## 1 Products affected

## 2 Type of change

## 3 Detailed description of change

| Product Change Notification |               |              |             |              | PCN CD, CE, CG - TOX, Label w/o P/N |        |             |

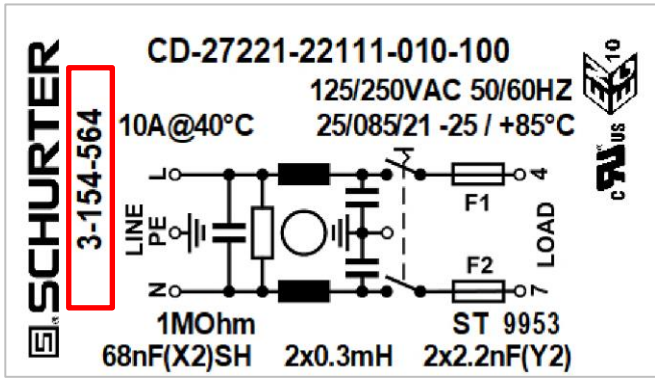
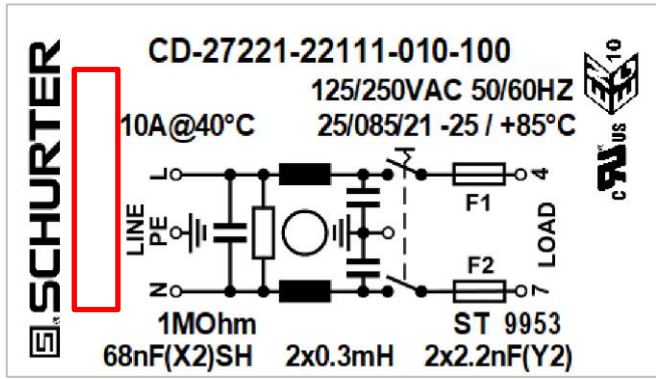
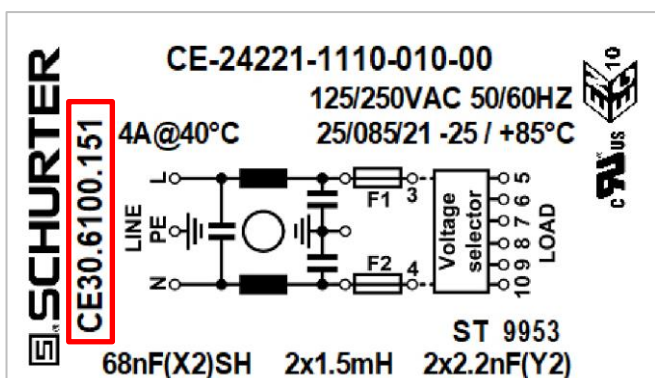
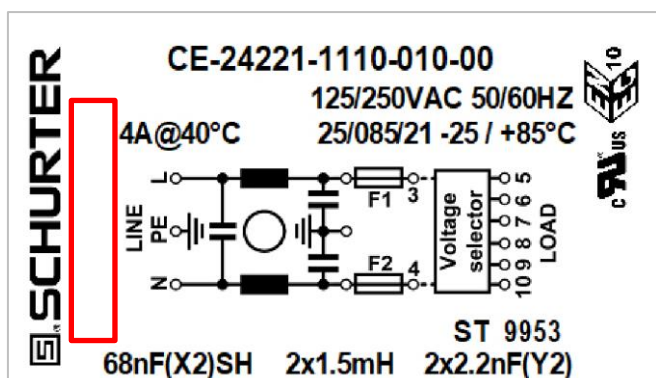
| Current product appearance                                                                                                                                                                                                       | New product appearance                                                                                                                                                                                                            |
|----------------------------------------------------------------------------------------------------------------------------------------------------------------------------------------------------------------------------------|-----------------------------------------------------------------------------------------------------------------------------------------------------------------------------------------------------------------------------------|
| Current product label                                                                                                                                                                                                            | New product label                                                                                                                                                                                                                 |
|  <p>CD-27221-22111-010-100<br/>125/250VAC 50/60HZ<br/>10A@40°C 25/085/21 -25 / +85°C<br/>1MOhm 68nF(X2)SH 2x0.3mH 2x2.2nF(Y2)<br/>ST 9953</p> |  <p>CD-27221-22111-010-100<br/>125/250VAC 50/60HZ<br/>10A@40°C 25/085/21 -25 / +85°C<br/>1MOhm 68nF(X2)SH 2x0.3mH 2x2.2nF(Y2)<br/>ST 9953</p> |
|  <p>CE-24221-11110-010-00<br/>125/250VAC 50/60HZ<br/>4A@40°C 25/085/21 -25 / +85°C<br/>1MOhm 68nF(X2)SH 2x1.5mH 2x2.2nF(Y2)<br/>ST 9953</p>   |  <p>CE-24221-11110-010-00<br/>125/250VAC 50/60HZ<br/>4A@40°C 25/085/21 -25 / +85°C<br/>1MOhm 68nF(X2)SH 2x1.5mH 2x2.2nF(Y2)<br/>ST 9953</p>   |

- Improvement of manufacturing process
- P/N removed from product label

- Production process improvement: Change from spotwelding to TOX clinching
- Production optimisation: Separation of the part and the packaging unit; the configuration code remains on the product, and the item numbers are printed on the packaging label.
- This change is part of the continuous improvement process

| <input checked="" type="checkbox"/> Label         | No action required, 2D Barcode on package label remains unchanged |

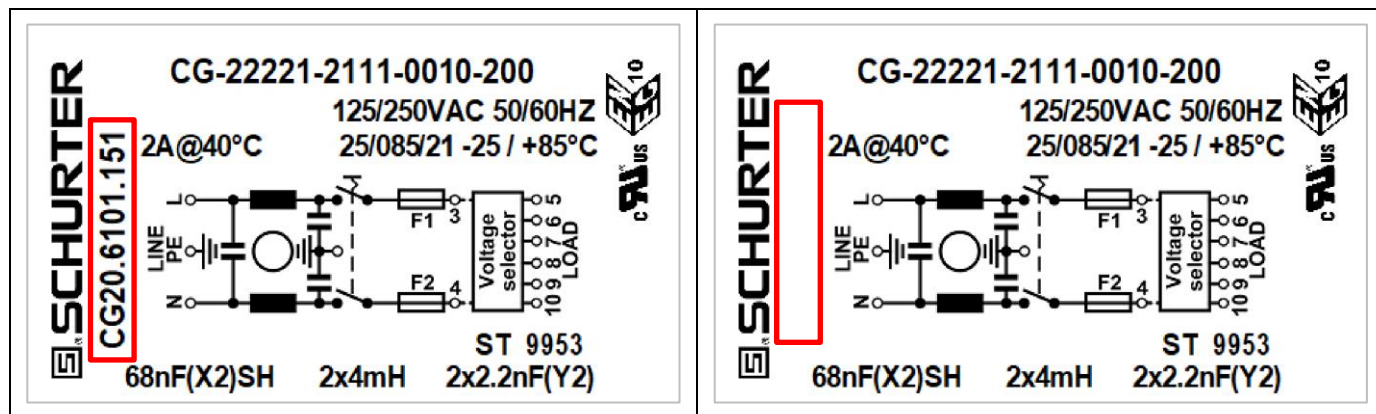
| Current product appearance                                                                                                                                                                                                       | New product appearance                                                                                                                                                                                                            |
| Spot welding joint                                                                                                                                                                                                               | TOX clinching joint                                                                                                                                                                                                               |
